**STAFF REPORT
DEVELOPMENT COMMISSION
ZONING MEETING
CITY OF COLUMBUS, OHIO
NOVEMBER 9, 2017**

- 5. APPLICATION: Z17-032**
Location: **8118 SANCUS BOULEVARD (43081)**, being 3.79± acres located on the east side of Sancus Boulevard, at the intersection with Brockwell Drive (610-231154; Far North Columbus Communities Coalition).
Existing Zoning: AR-12, Apartment Residential District.
Request: CPD, Commercial Planned Development District.
Proposed Use: Police substation
Applicant(s): City of Columbus; c/o Heather L. Brink; 90 West Broad Street; Columbus, OH 43215.
Property Owner(s): The Applicant.
Planner: Shannon Pine; 614-645-2208; spine@columbus.gov

SITE COMPLIANCE PLAN FOR POLARIS POLICE SUBSTATION 8118 SANCUS BOULEVARD SITE PLAN

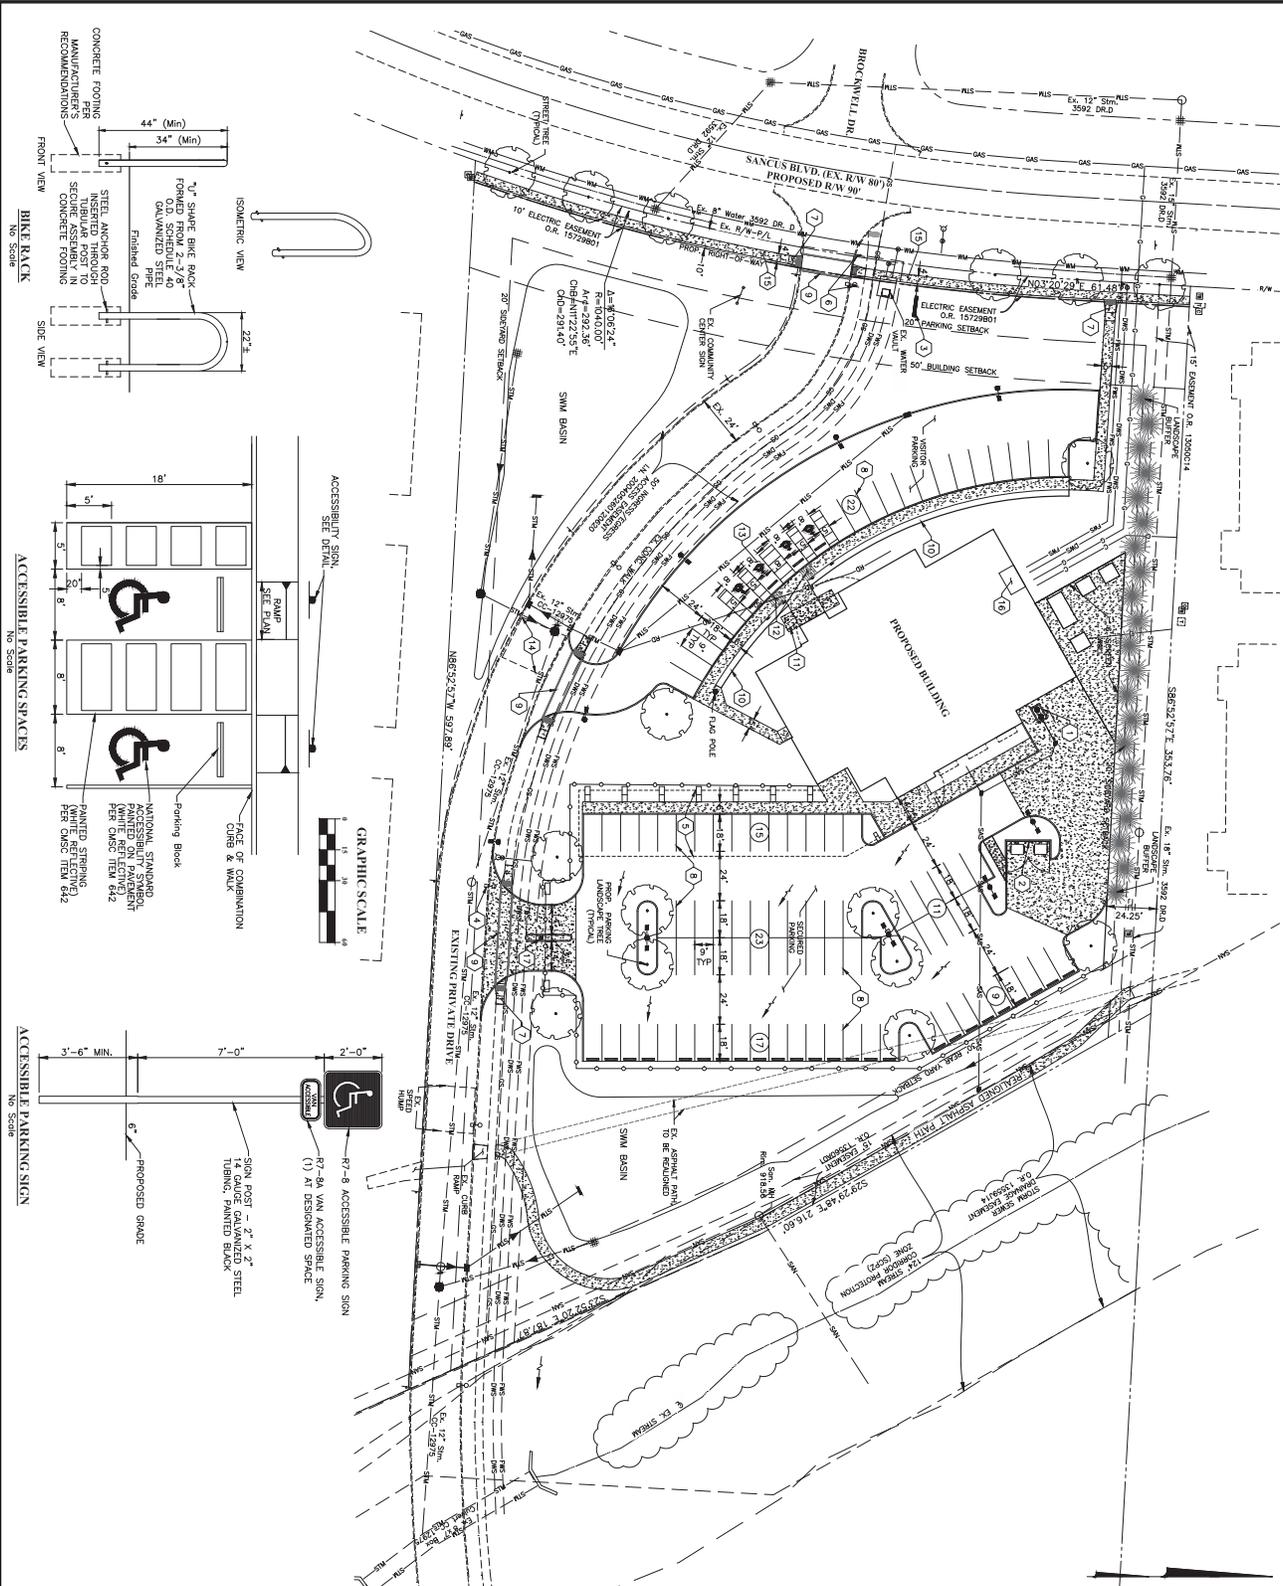
CITY DEPARTMENTS' RECOMMENDATION: Approval.

The requested CPD, Commercial Planned Development District will allow the construction of a new police substation. Staff supports the proposed use, which is consistent with the land use recommendation of the *Far North Area Plan*, and the proposed site design which is compatible with the adjacent recreation center. The request is consistent with the zoning and development pattern of the area.
